Betts Industries, Inc.

Engineering Bulletin 1-2000

Subject: Replacement Kits to Upgrade 10" Fill PAF Style Pressure Relief Valves to Meet "Less Than One Liter Leakage" Requirements

FIG. 1

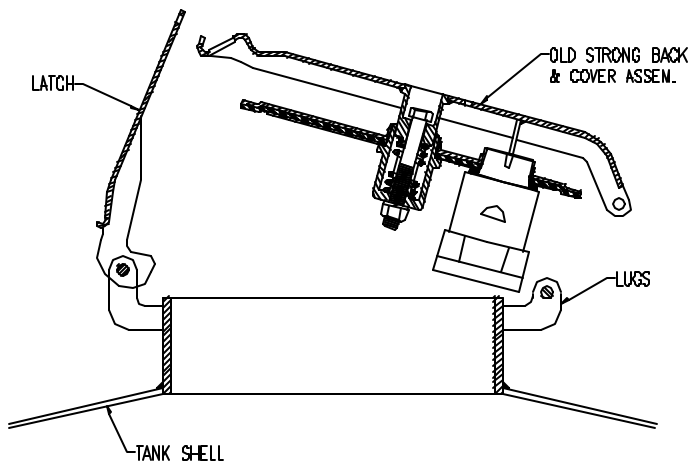
1. Remove existing strongback and cover. (Fig. 1) Do not remove latch. (Some models may require spot welds to be ground from the hinge pin to remove strongback. Use caution - do not damage lugs.)
2. Install replacement kit using supplied hinge pin and cotter pins. (Fig. 2)
3. Check assembly to verify proper operation.
 - a) Verify the fill cover opens and closes without binding.
 - b) Verify the fill cover lays flat on the seat in the closed position.
 - c) Verify the latch freely engages the strongback and closes with moderate force.
 - d) If the set pressure requires adjustments, please refer to "Instructions for Set Pressure Adjustment" included with replacement kit.
